**BEFORE THE HEARINGS PANEL
FOR PROPOSED PRIVATE PLAN CHANGE 31 TO THE WAIMAKARIRI
DISTRICT PLAN**

IN THE MATTER of an Application by Rolleston Industrial Developments Limited for a private plan change to the Waimakariri District Plan pursuant to Part 2 of the Schedule 1 of the Resource Management Act 1991

**STATEMENT OF EVIDENCE OF BEN WILKINS ON BEHALF OF THE
CANTERBURY REGIONAL COUNCIL**

21 JULY 2023

ATTACHMENT 2 – GROUNDWATER LEVEL MONITORING WELLS

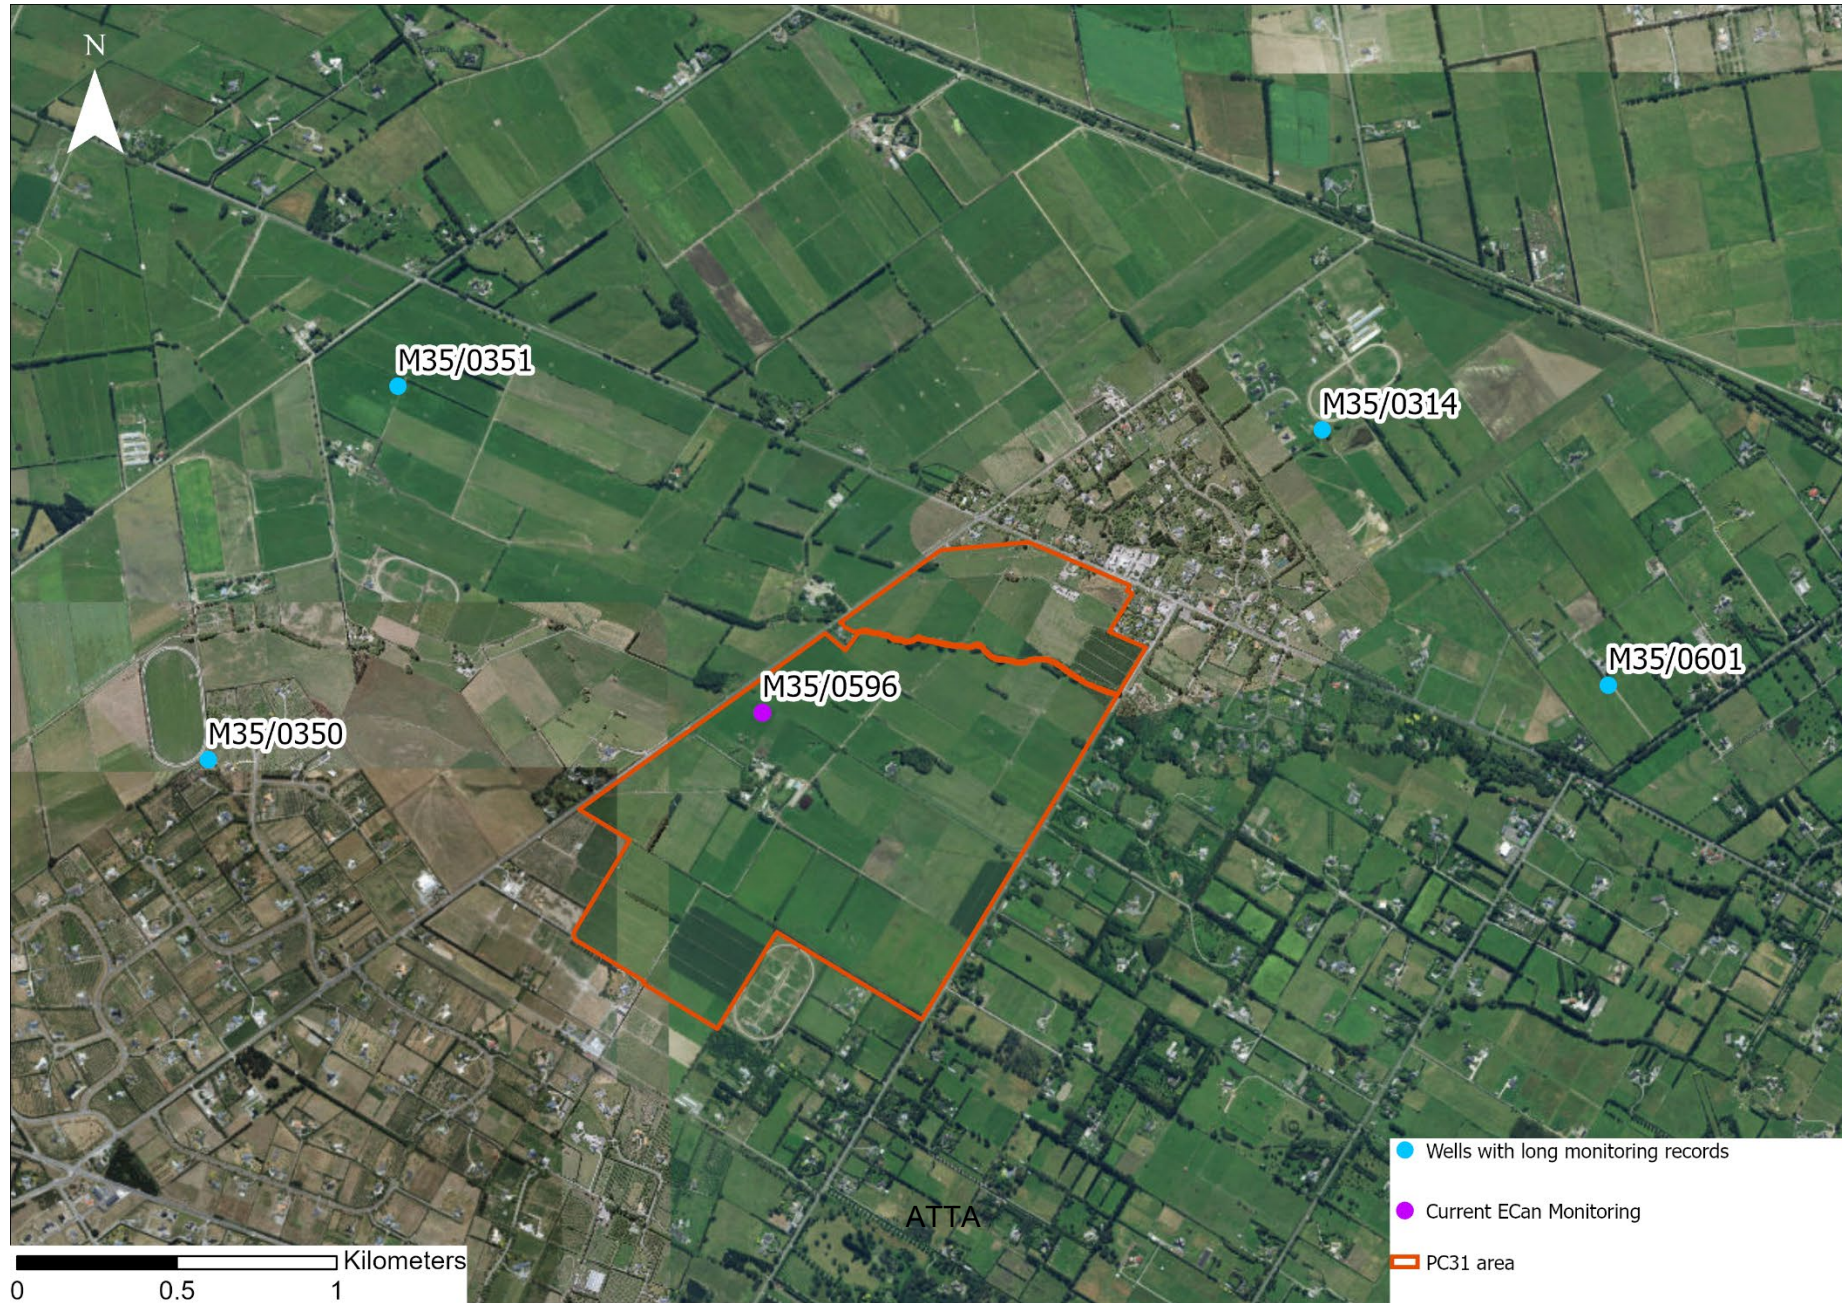
- 21 Groundwater levels are monitored monthly in the PC31 area (**Attachment 2**) by the CRC at well M35/0596.
- 22 M35/0596 is 2.90 metres deep. The water level at this well has been measured since 1977 (however, it was not measured between 1987 and 1998) and it is currently still part of the CRC's groundwater level monitoring network. There are 415 water level measurements recorded at this well, over a period of 34 years.
- 23 A key detail of this well is that it has a standup of 0.5 metres above ground level (**Attachment 3**). The well standup is an extension of the well above ground level. It prevents surface water from flowing into the well.
- 24 The water level is measured from the top of the standup. Therefore, the 0.5 metre standup height of the well above ground level must be subtracted to determine the highest water level in relation to the ground level (**Attachment 3**).

- 25 In my opinion, groundwater levels are often close to the surface across the PC31 area.
- 26 The highest groundwater level at M35/0596 is 0.12 metres below ground level (m bgl), recorded this year in March 2023 (**Attachment 4**).
- 27 The groundwater level in M35/0596 has been less than 0.5 m bgl in 23 months over the last 10 years (**Attachment 5**). The data provides a reliable indication that groundwater levels are close to the surface in the PC31 area.
- 28 Two springs and a groundwater seep have also been identified in the PC31 area, which also indicates that groundwater is close to the surface.
- 29 For comparison, I have reviewed recorded groundwater levels for nearby wells that have long records of groundwater level monitoring (**Attachment 2**). These support my interpretation that groundwater levels at the PC31 area are near the surface:

- a. Well M35/0314, which is one kilometre northeast of the PC31 area has 133 water level measurements (from 1974 to 1987) and has a highest water level of 0.15 m bgl (recorded in June 1980).

- b. Well M35/0351, which is 1.5 kilometres northwest of the PC31 area, has 23 water level measurements (from 1977 to 2011). The highest water level at this well is 0.26 m bgl (recorded in September 1978).

- c. Well M35/0350, which is 1.5 kilometres west of the PC31 area, has 17 water level measurements (from 1977 to 1986). The highest water level is 0.04 m bgl (recorded in 1978).

- d. Well M35/0601, which is 1.5 kilometres east of the PC31 area has 443 water level measurements (from 1973 to 2023). The highest water level is 0.19 m above ground level (recorded in August 2012).

ATTACHMENT 3 – WELL STANDUP IMAGE

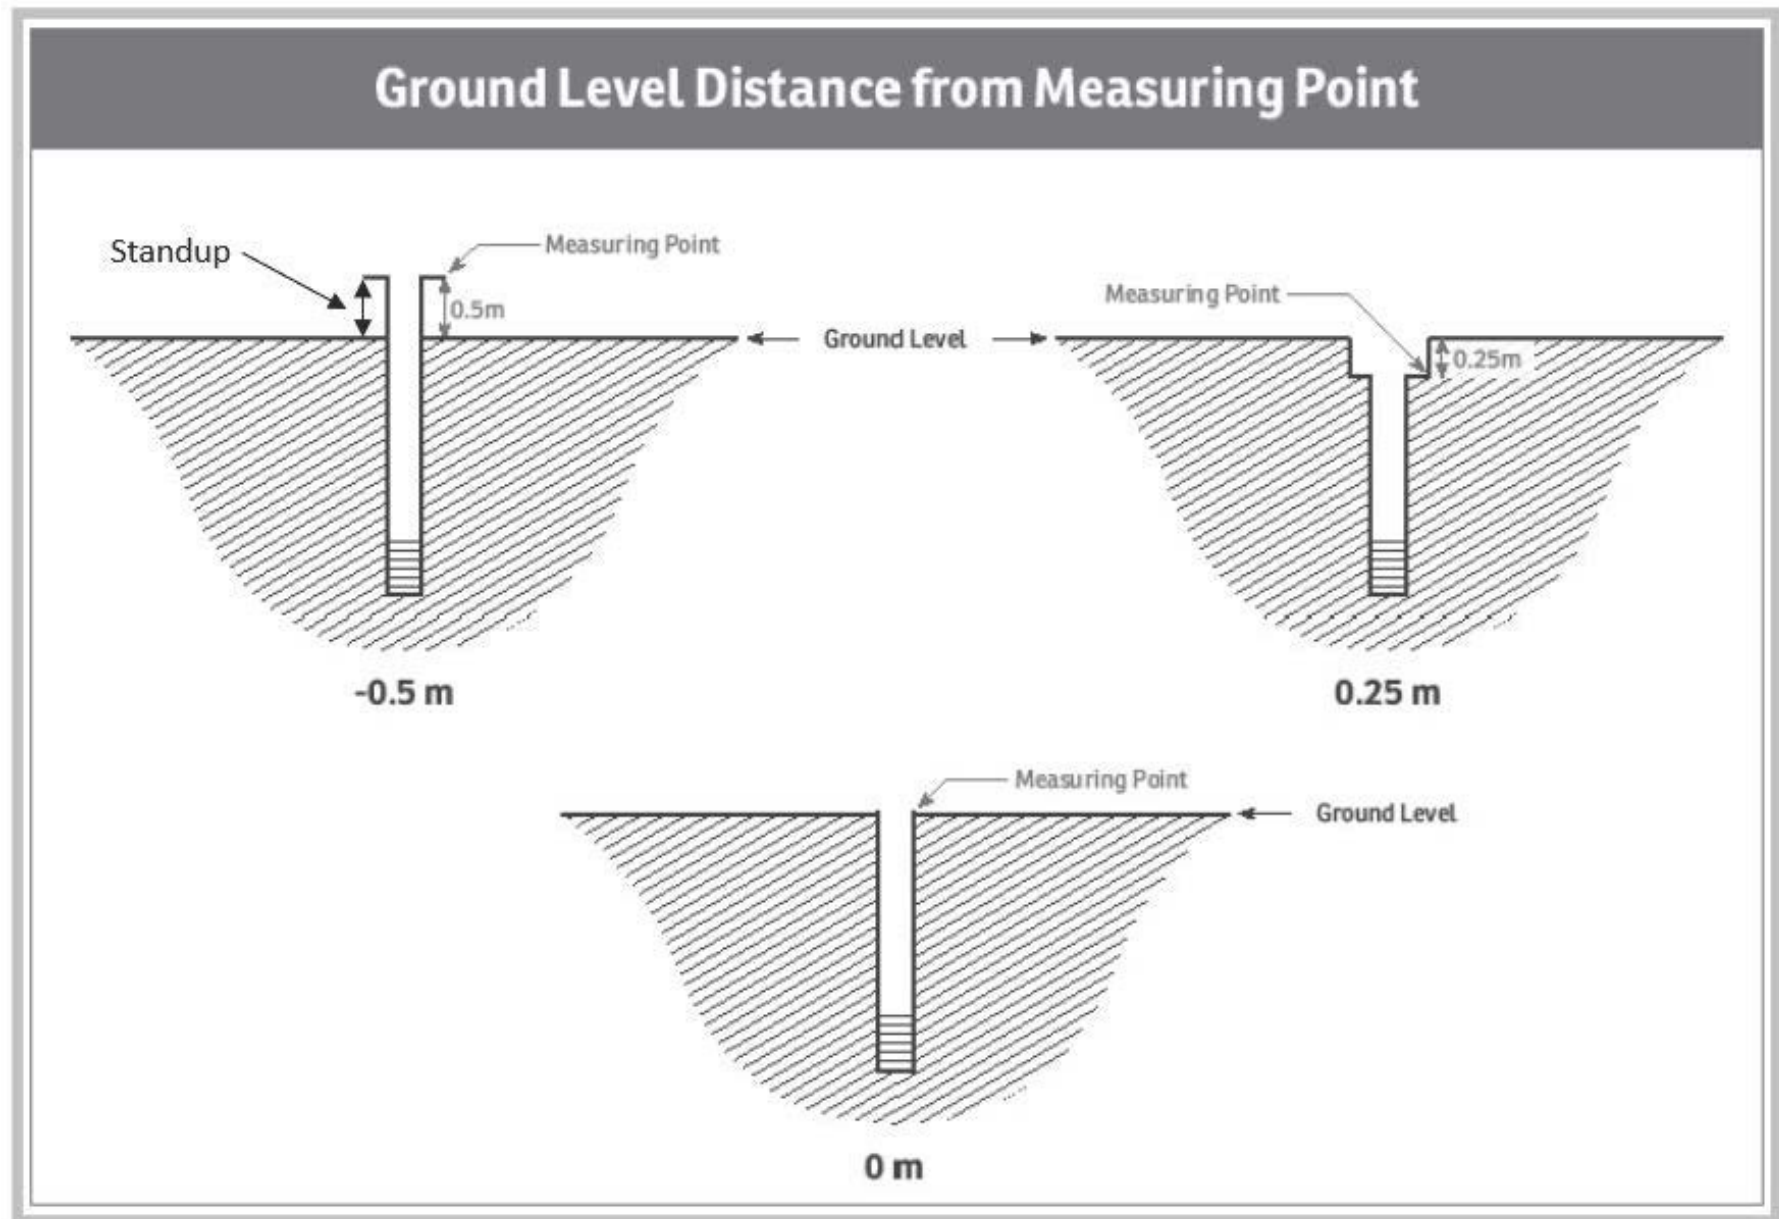
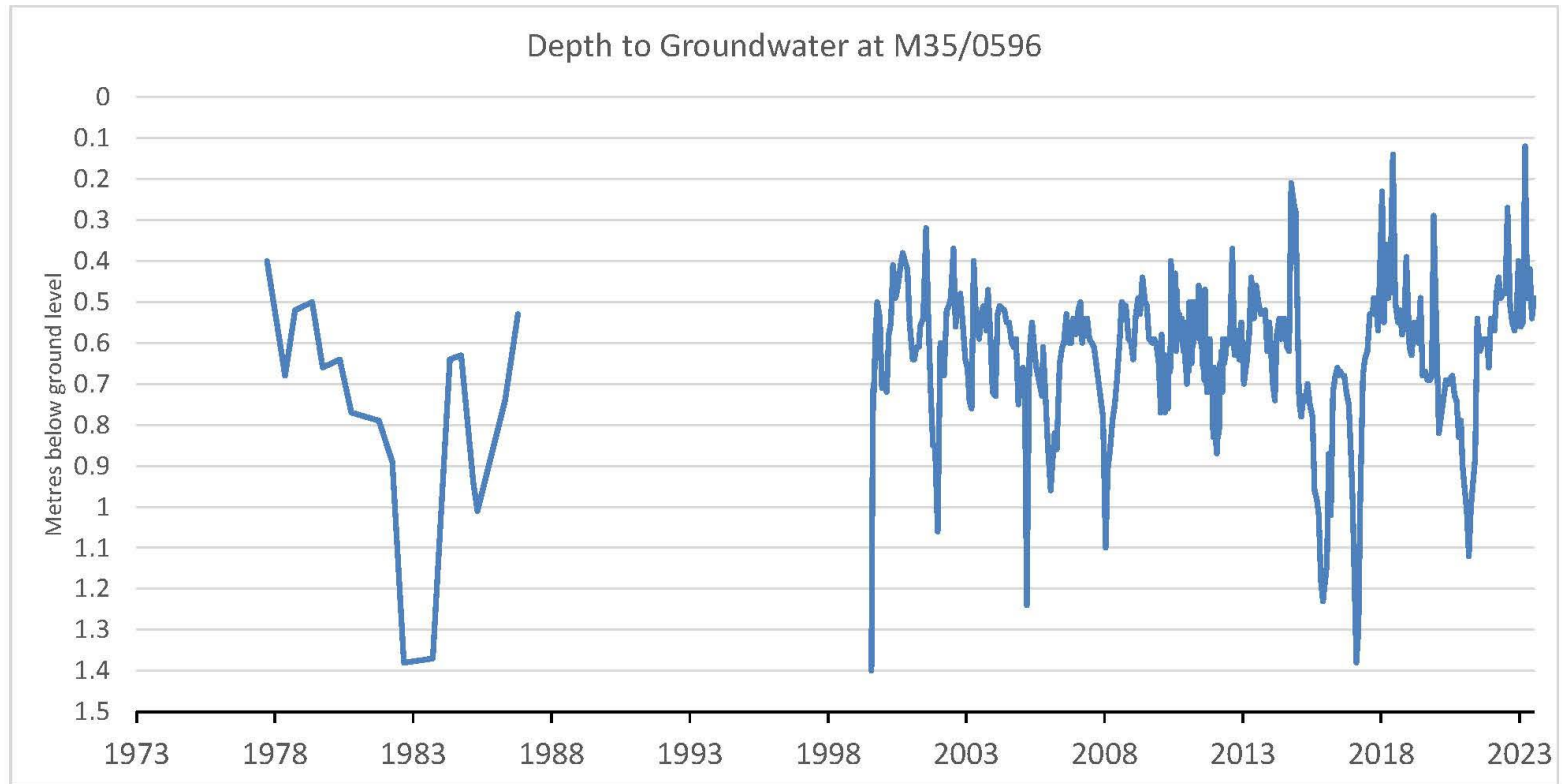
- 31 I do not consider that the Applicant has accurately and consistently assessed the groundwater levels across the PC31 area, in large part due to the fact that the Applicant does not appear to have subtracted the standup of well M35/0596 from the groundwater level readings and has used a short time period to characterise groundwater levels at the PC31 area, which does not capture the variability of the area. Additionally, the most recent highest water level has not been reported. The reasons for my opinion and conclusions are explained further in the following paragraphs.

- 32 In Appendix A – Assessment of Potential Loss of Productive Land³ the standup of the well above ground level has not been subtracted and therefore a deeper highest groundwater level of 0.645 m bgl at M35/0596 is reported. This incorrect level is also referred to in the Statement of Evidence of Victor Mkurutsi Mthamo dated 6 July 2023.⁴
- 33 The implications of a higher groundwater level for this assessment are significant as it relates to the assessments of drainage, nutrient and contaminant losses, soil vulnerability as well as groundwater and surface water interactions.
